LOCAL HISTORIC DISTRICT: Dilworth

PROPERTY ADDRESS: 409 Rensselaer Avenue

SUMMARY OF REQUEST: Addition

**Charlotte Historic District Commission Case 2017-683
HISTORIC DISTRICT: DILWORTH
ADDITION**

1 PROPOSED REAR ELEVATION
1/4" = 1'-0"

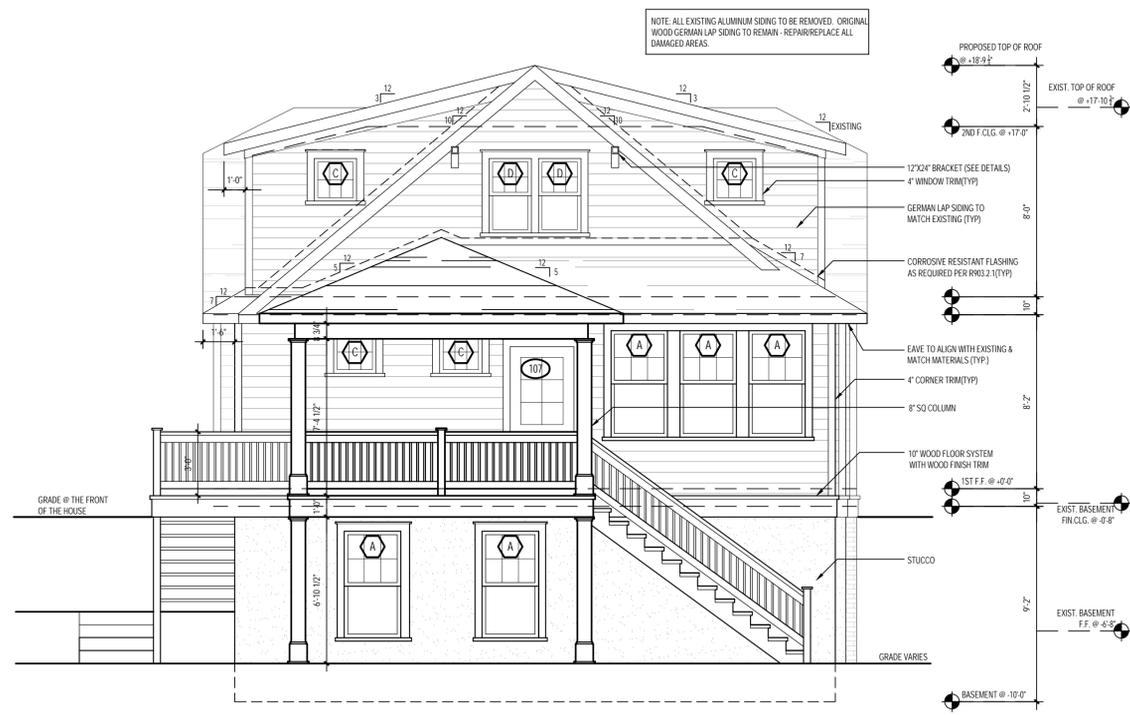
1. The applicant has modified the rear elevation roof form to address massing including a revised dormer design on the left and right side.
